Subject: 10CFR21 Reporting of Defects and Non-Compliance -
Engine Systems, Inc. Report No. 10CFR21-0114, Rev. 0

Subcover Assembly, P/N 1A-7846

COMPONENT: Subcover Assembly, P/N 1A-7846

SYSTEM: Emergency Diesel Generator

Figure 1: Outline Drawing of Subcover

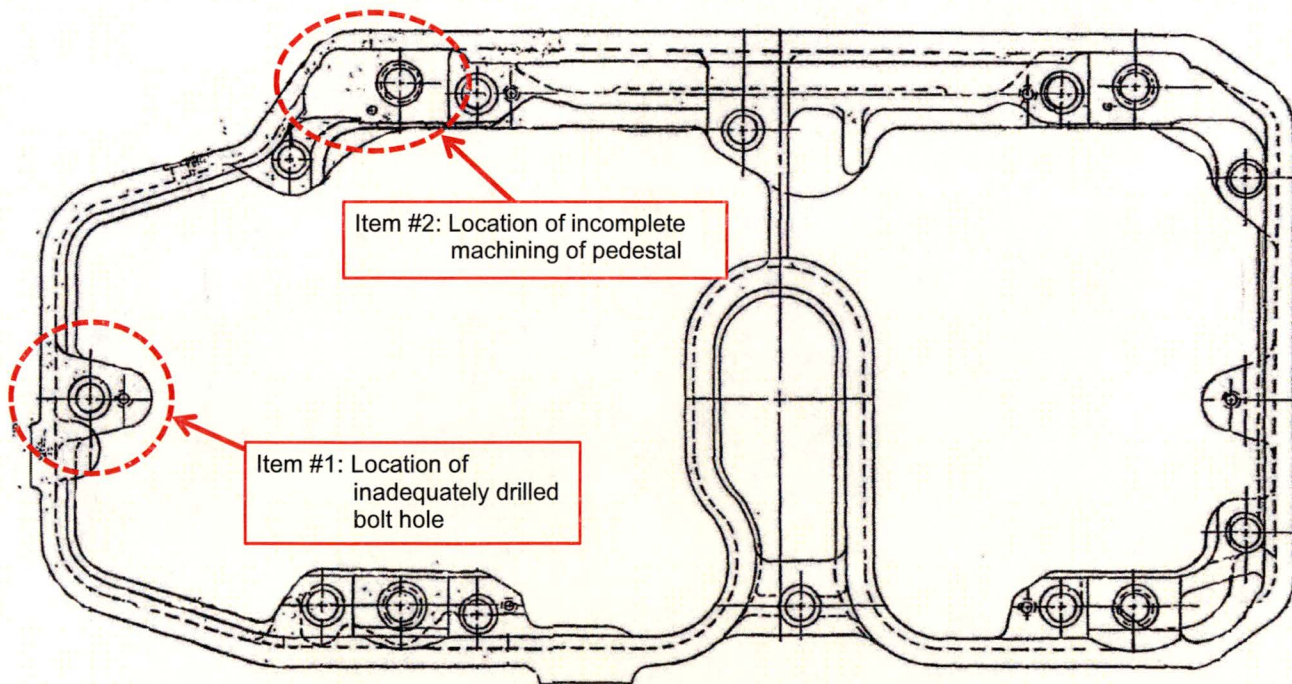
Engine Systems Inc. (ESI) began a 10CFR21 evaluation on November 18, 2016 upon notification of an issue with a subcover assembly at Perry Nuclear Plant. Attempts to install the subcover on their Enterprise diesel engine revealed two issues that prevented successful installation. First, one of the bolt holes was not fully machined through the entire depth of the subcover. Though the bolt could be inserted into the top of its corresponding hole, it would not pass completely through. The second issue was an interference between the rocker arm shaft and its mating pedestal. It was found that incomplete machining of the pedestal prevented the shaft from sitting flat on the pedestal.

The issue regarding the inadequately drilled bolt hole would be detected during installation since it would prevent the bolt from passing through the hole. Therefore, it is determined this issue would have no impact on operability since the cover could not be installed with an incompletely drilled bolt hole.

- Inspect for the bolt hole (item #1). If rework is necessary, drill through to a diameter of 13/16".
- For the incomplete machining of the rocker arm pedestal (item #2), first remove the installed dowel which has 0.000" to 0.001" clearance. Then machine a 2" radius relief at the affected area. All other dimensions such as pedestal height shall remain unchanged.

Photo 2: Attempted Bolt Install

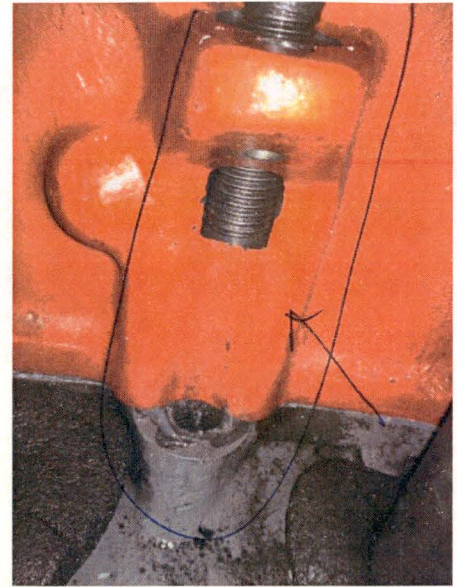
Photo 1: Visual Depiction of Inadequately Drilled Bolt Hole

Figure 2: Ideal Pedestal Machining

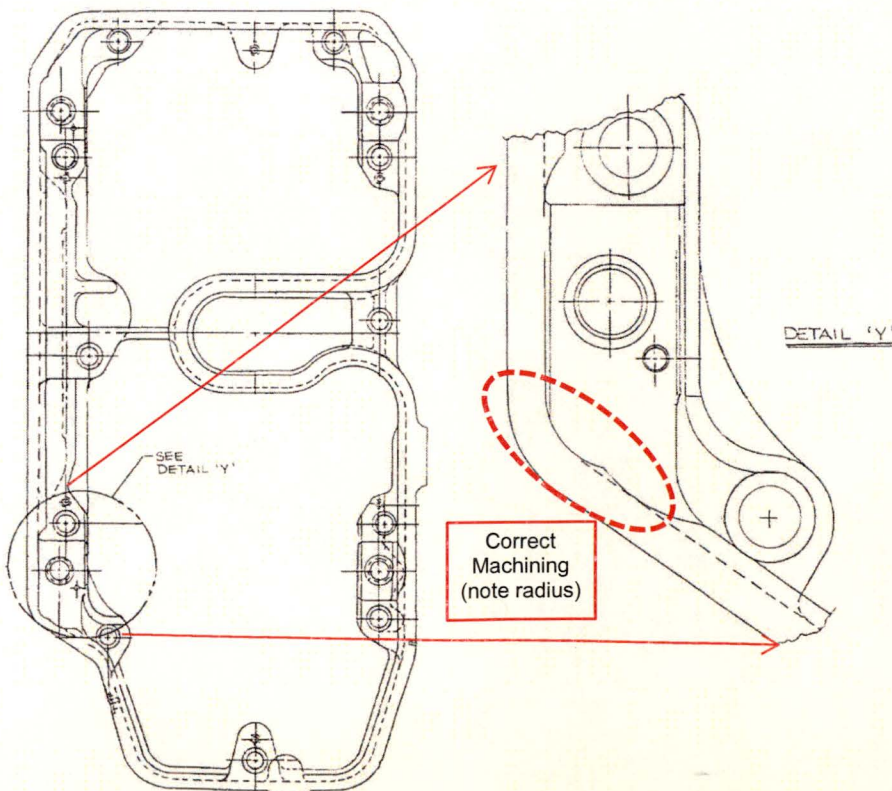
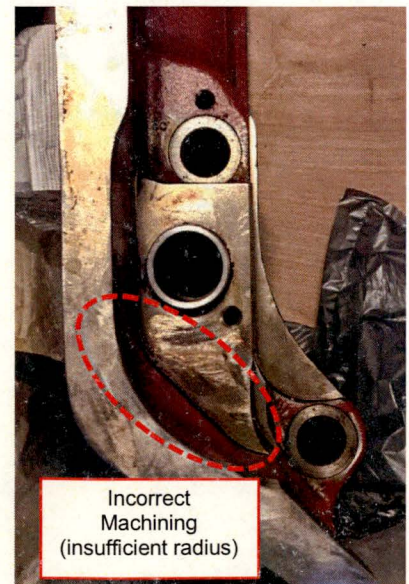
Photo 3: Actual Machining

With regard to the incompletely machined pedestal, there is the potential that a customer could install the rocker arm shaft without detecting this issue. In this situation, the shaft will partially fit on the pedestal and the bolt will thread into subcover; however, the shaft will not seat fully on the pedestal. This prevents full contact with the pedestal and inhibits adequate preload throughout the bolted joint. If a customer were to install the rocker arm shaft (with mating rocker arms, pushrods, etc) onto the engine without realizing this issue, operability and durability of the engine would be compromised. This could present a substantial safety hazard.
